DEPT. OF ENGINEERING, HARTFORD CONN. ROBERT J. ROSS, CITY ENGINEER, & MANAGER, MET. DIST. BUR. PUBLIC WKS.		
FOR THE FLOOD COMMISSION OF THE CITY OF HARTFORD		
CONTRACT DRAWING, CONSTRUCTION OF		
ACCESS ROAD TO NORTH MEADOWS PUMPING STATION		
SCALES AS SHOWN		
SUBMITTED Charles H. Cooke DIVISION ENGINEER	RECOMMENDED NADW ASST. CITY ENG.	APPROVED Robert J. Ross CITY ENGINEER
DRAWN C.C.R.		DAYBOOK NO. 08263
TRACED C.C.R.		CHECK
SEPTEMBER 1941

SHEET
1
OF 2 SHEETS

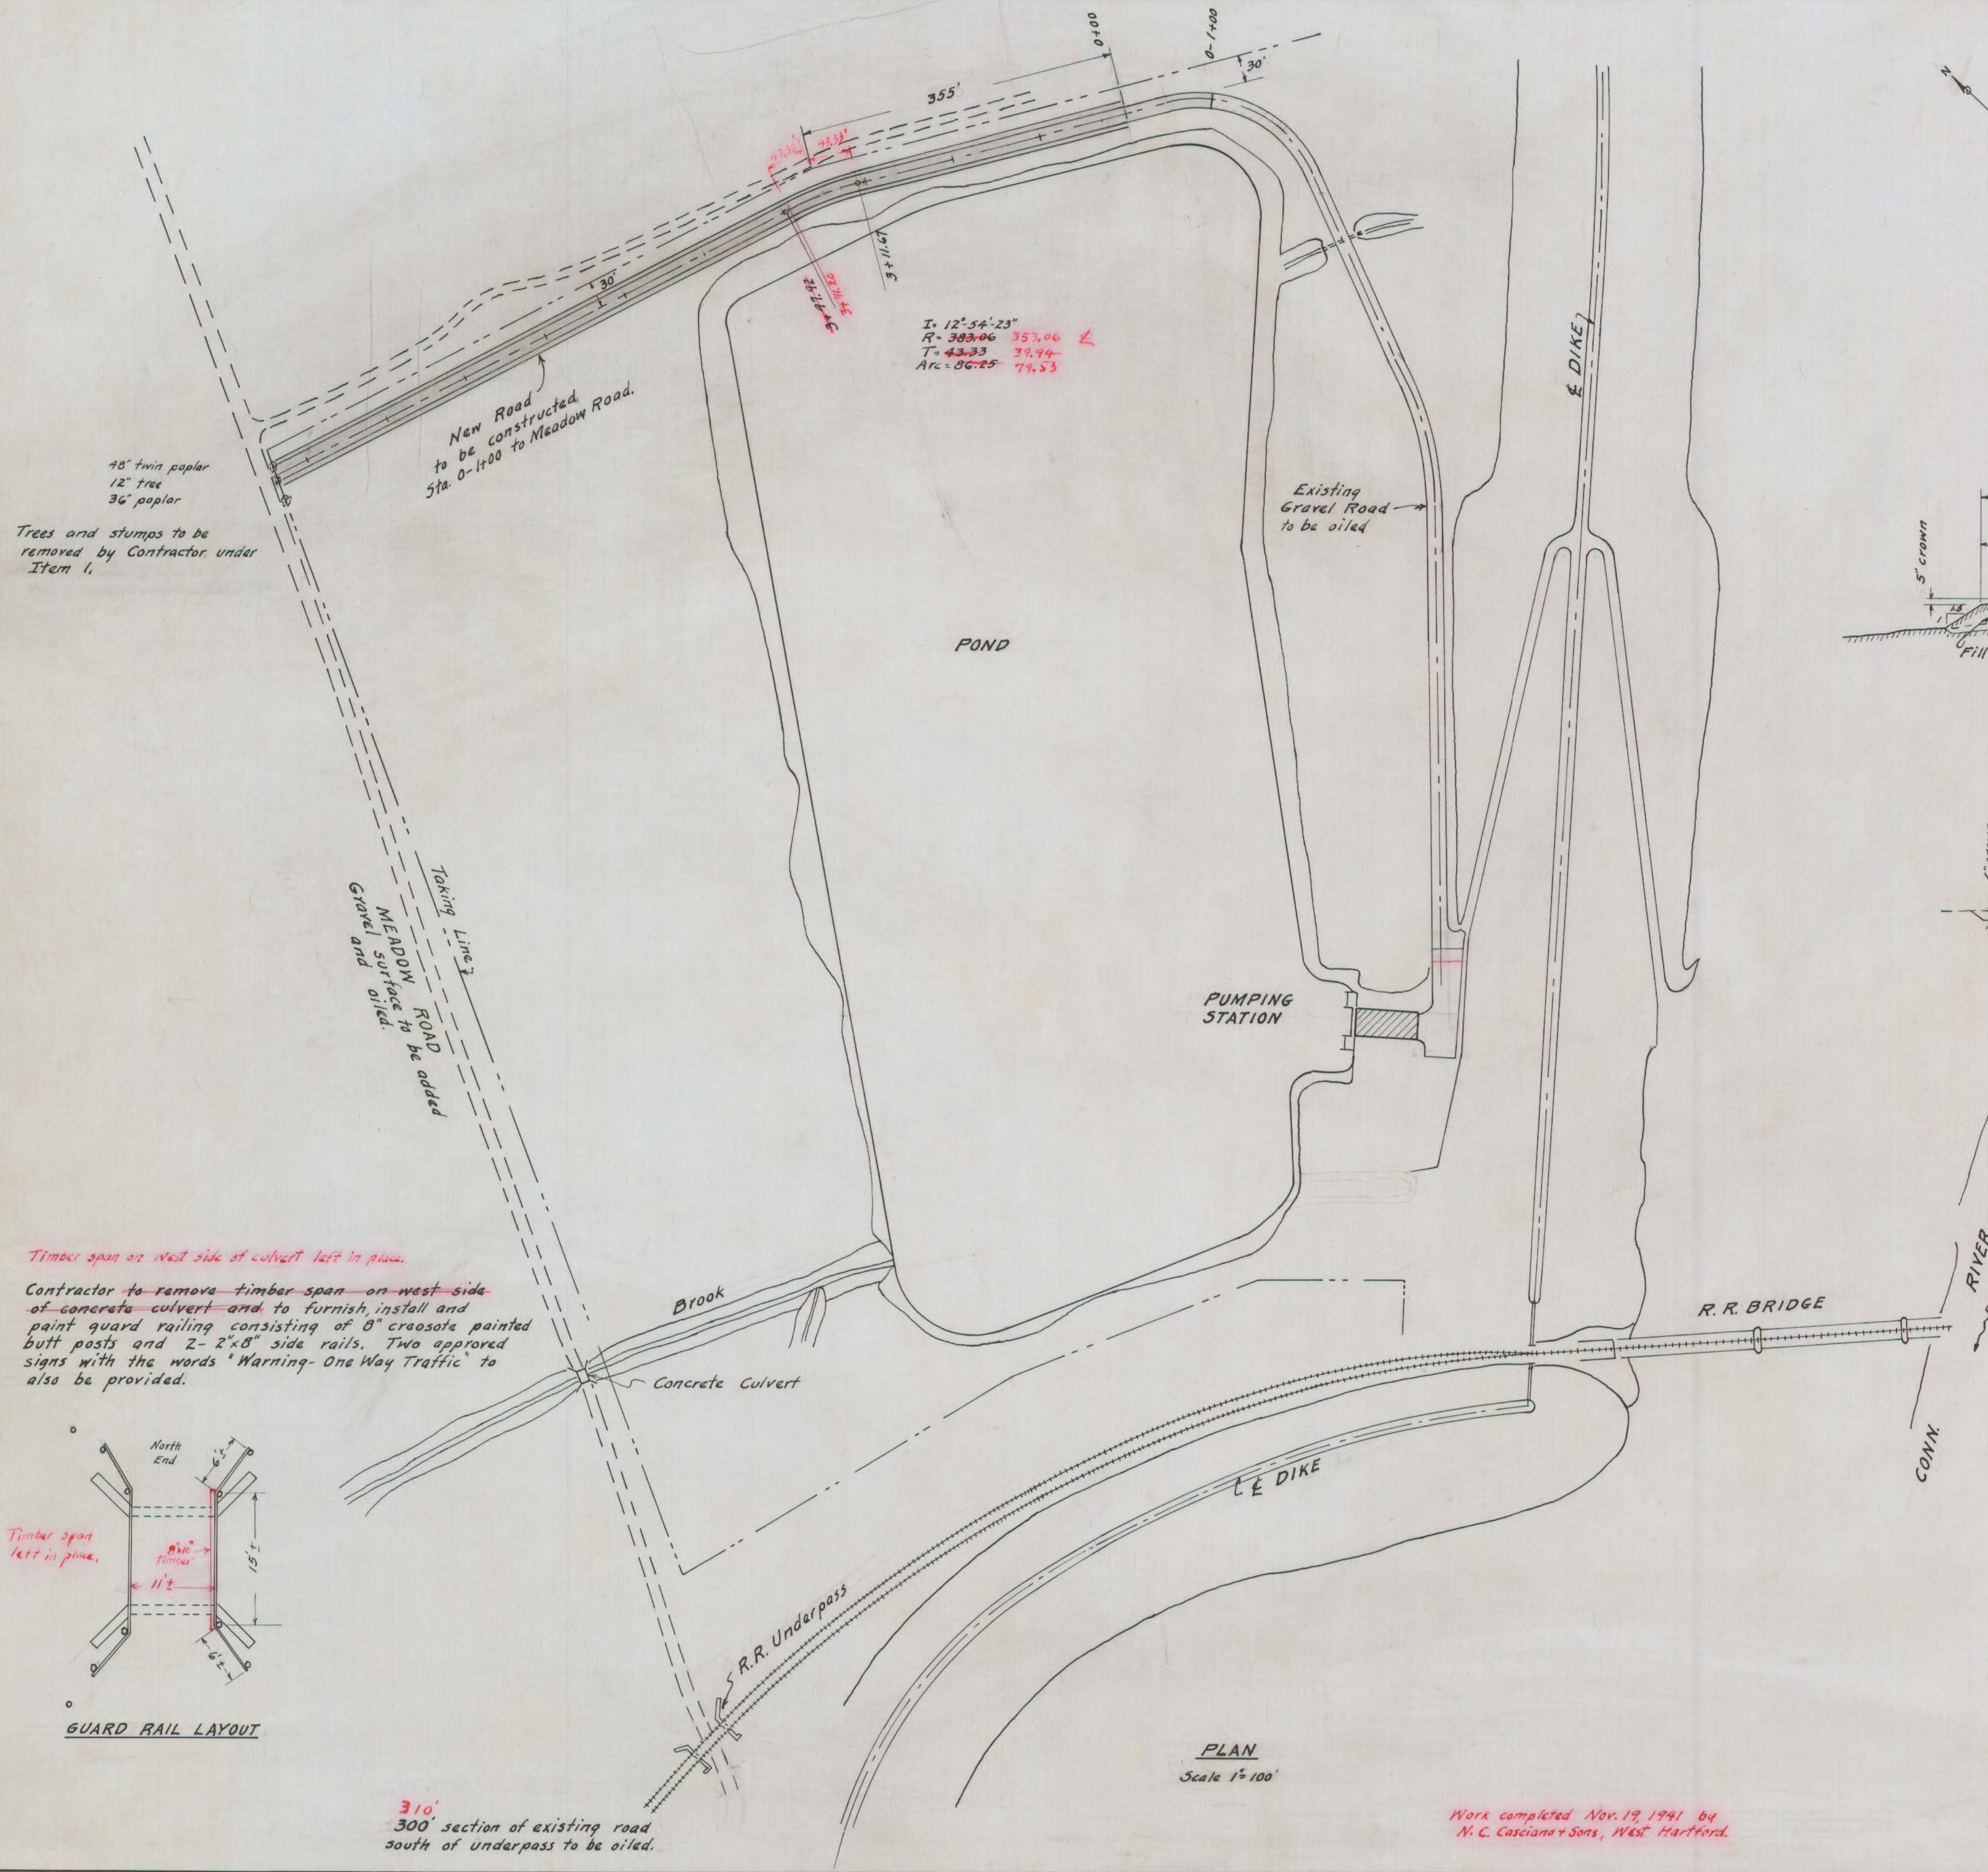
Timber span on west side of culvert left in place.

Contractor to remove timber span on west side of concrete culvert and to furnish, install and paint guard railing consisting of 8" creosote painted butt posts and 2-2"x8" side rails. Two approved signs with the words "Warning- One Way Traffic" to also be provided.
